Planning Commission Study Session

SUBJECT: S18-18, ASPIRE HERITAGE DISTRICT

S18-18 Aspire Heritage District: Preliminary Plat and Open Space Plan for Aspire Heritage District, for thirty-two (32) residential home lots (Lots 1-32) on approximately 2.47 acres of real property generally located at the northeast corner of Vaughn Avenue and Palm Street in the Multi-Family/Low (MF/L) zoning district.

PRELIMINARY PLAT
ASPIRE HERITAGE DISTRICT
124 E VAUGHN AVE.
GILBERT, AZ 85234

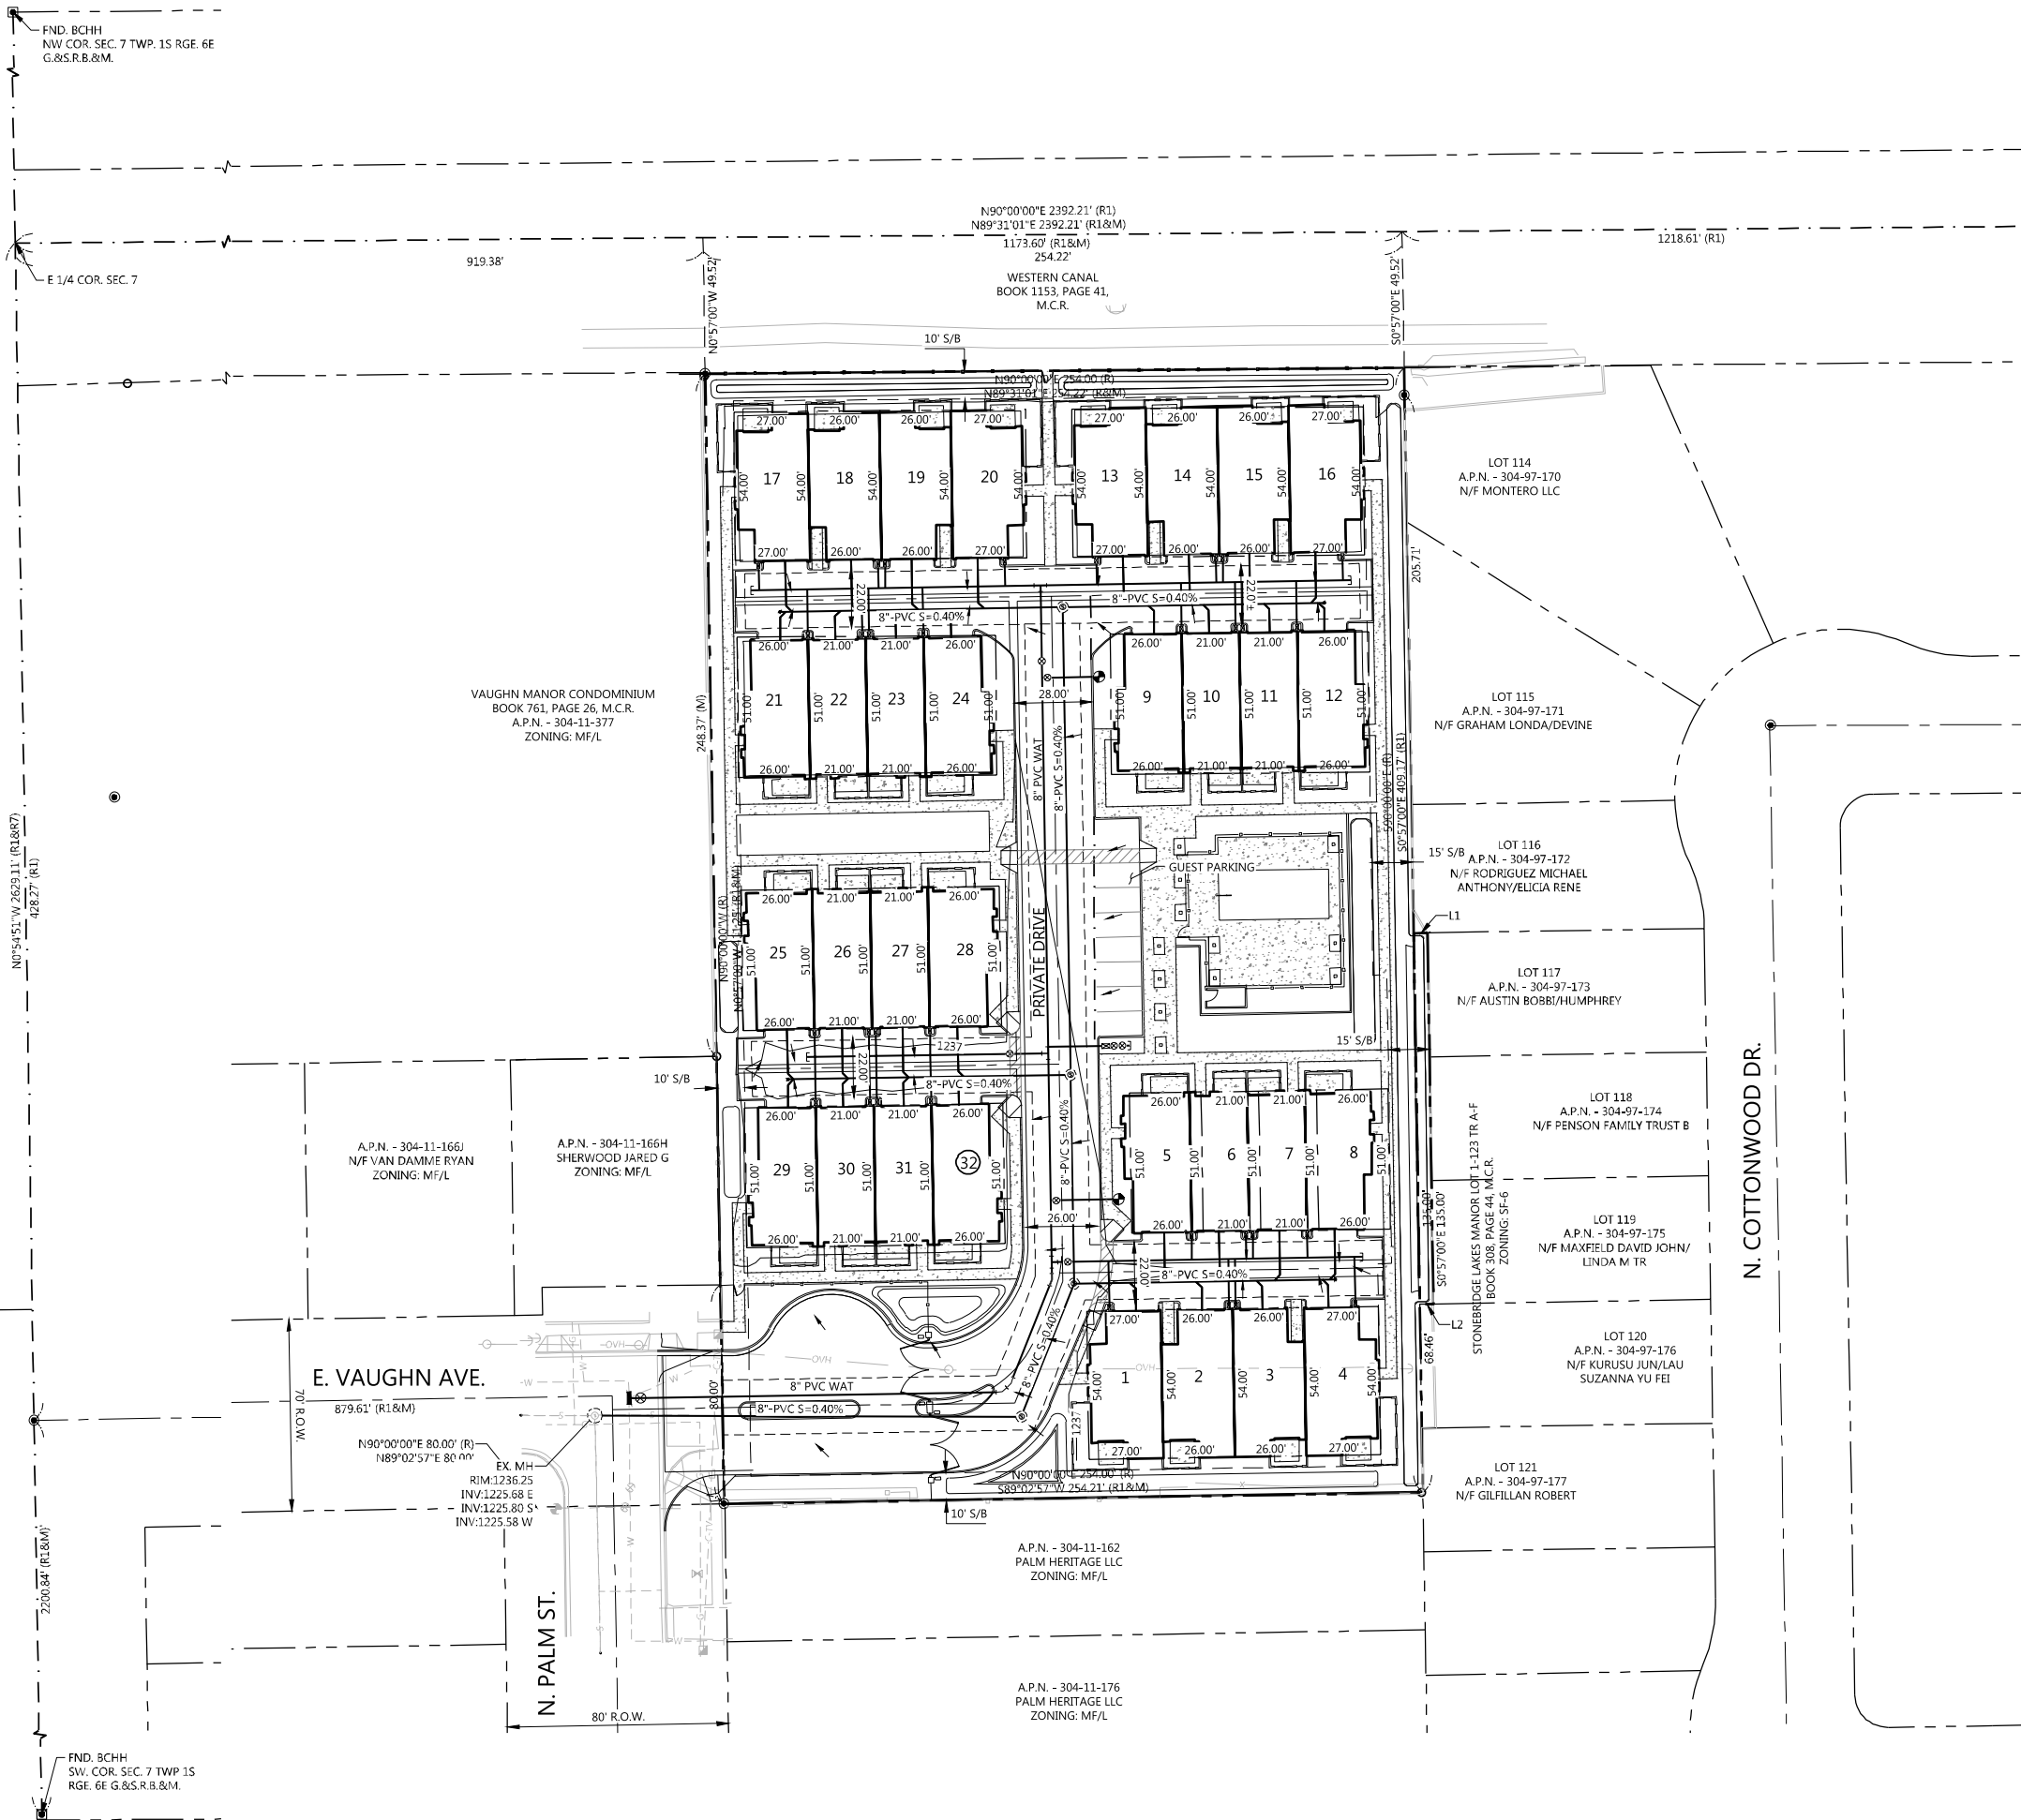
The subject site has one (1) point of vehicular access located at the intersection of Vaughn Avenue and Palm Street. Internally, the site consists of a central private drive that connects to four (4) individual access alleys. The main private drive is approximately 28' in width with the individual access alleys being approximately 22' wide. Each proposed unit includes a two (2) car garage located in the rear of each building cluster for resident parking. For guest parking, a total of eight (8) parking spaces have been provided; the spaces are located adjacent to the amenity area.

Pedestrian pathways are located within the site along with two (2) pedestrian gates. One pedestrian gate is located at the entrance of the site and the other in the rear of the site, providing access to the Powerline Trail/Consolidated Canal. The sidewalks provided internally to the site are 4' wide. Staff has noted that the addition of a supplementary pedestrian walkway to the south along the entrance, with a pedestrian gate, would increase pedestrian circulation and access for the site. The project is planned to develop as a single phase. Please see table below for the development standards reflected in this preliminary plat and open space plan.

3 SITE WALLS SCALE: 3/8" = 1'-0"

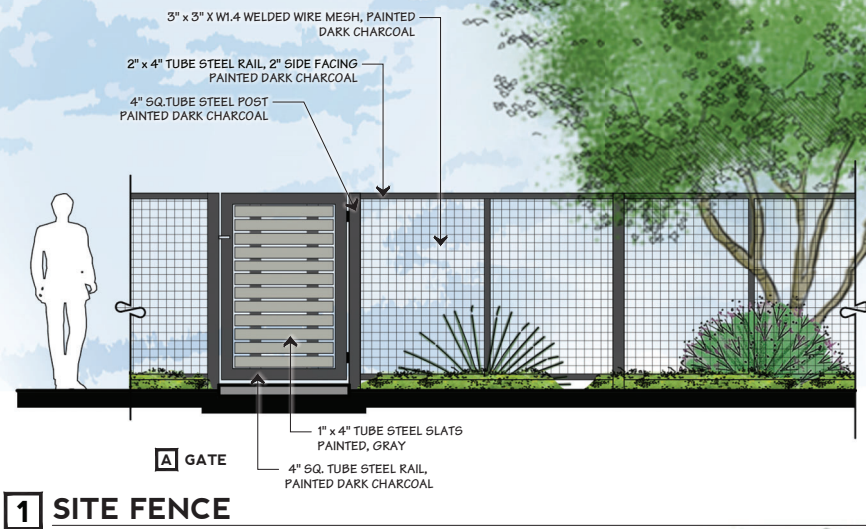
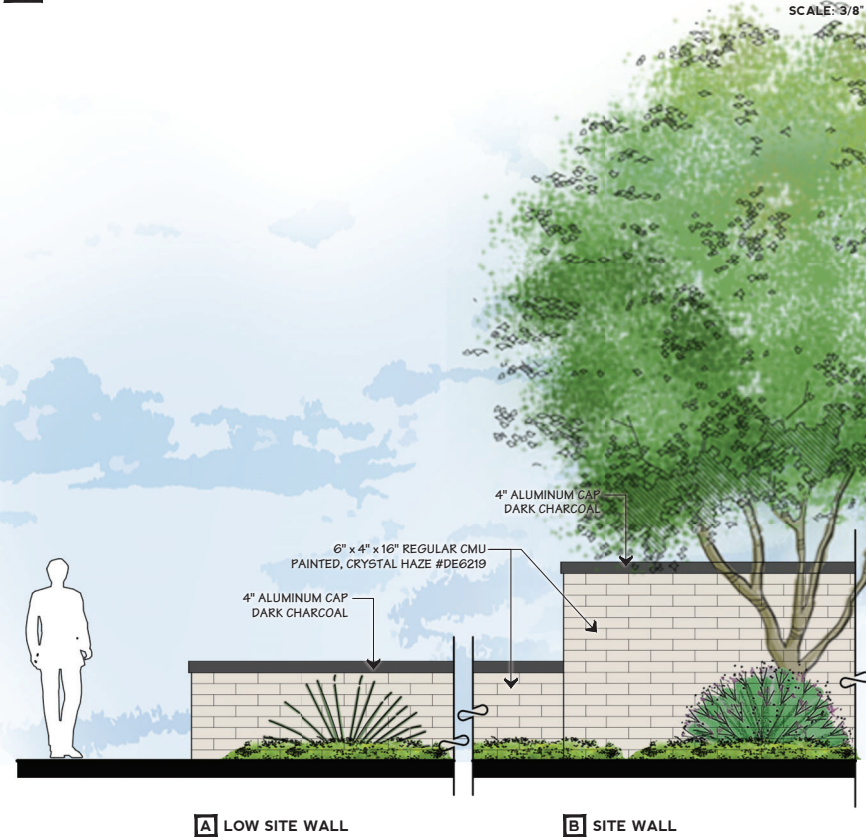
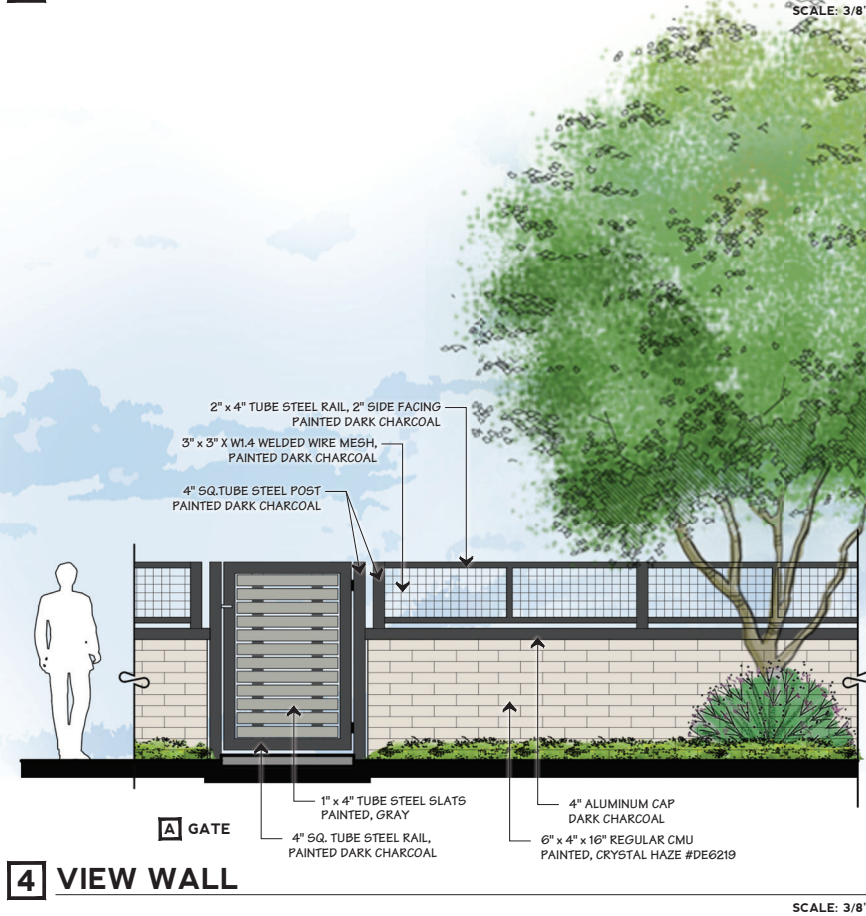
The site contains one (1) amenity area located toward the center of the site. The amenity area includes a swimming pool, cabana, and grass play area. The existing walls to the east and west are to remain with new perimeter walls proposed to the north, south, and adjacent to the vehicular entrance. To the south, abutting an existing single family residence, the wall is to be 8' solid CMU. The site fence wall adjacent to the entrance, at the northeast corner, is proposed to be a decorative metal view fence painted dark charcoal. To the north, along the canal, a CMU block fence with a decorative metal view fence feature on the top is proposed.
